**ISSUES PAPER ON PROPOSED REVISIONS TO THE ACCESS ARRANGEMENT FOR THE SOUTH WEST INTERCONNECTED NETWORK**

**ATTACHMENT 1****RESPONSE TO ISSUES PAPER ON PROPOSED REVISIONS TO THE ACCESS ARRANGEMENT FOR THE SOUTH WEST INTERCONNECTED NETWORK**

**Figure 1 - Flow of Customer Access NFI to the capital base via the Capital Contributions Policy**

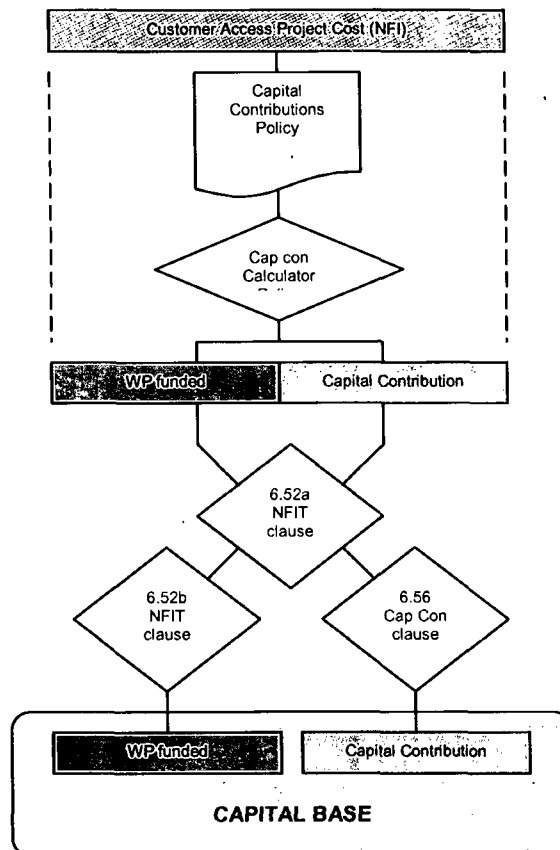
The first and second dot point under paragraph 72 of the issues paper identifies the following matters that the Authority will examine in relation to Western Power’s application of the New Facilities Investment Test:

- The absence of distinction by Western Power between the new facilities investment that is rolled into the capital base by virtue of meeting the new facilities investment test, from that rolled into the capital base by virtue of being financed by capital contributions.; and
- The potential inconsistency of claims by Western Power that the entire amount of new facilities investment meets the new facilities investment test, with the charging by Western Power of capital contributions — the latter only being possible in respect of new facilities investment that does not pass the new facilities investment test, with some limited exceptions.

In response to these issues, Western Power would like to bring to the attention of the Authority that the justification for the AA#1 expenditures being included in the regulated asset base is contained in the Appendix 5 of the Access Arrangement Information (Assessment of AA1 Capex – NFIT Submission). Section 5.2 addresses the issue of how NFI is included in the asset base by virtue of meeting section 6.52 of the Code or 6.56 of the Code. Note that the Code has since been amended and the provisions are now in sections 6.51A and 6.52.

For example, the following diagram details Western Power’s approach and is included in the submission:

Paragraphs 2 and 3 of section 5.2 state:

“New facilities investment in Customer Access projects typically includes a portion of NFI that is funded by Western Power and meets leg (i) of Part (b) of the NFIT, commonly referred to as the “incremental revenue leg”.

The remainder of the NFI in a Customer Access project is funded by the customer and may be added to the capital base via clause 6.56 of the Code.”
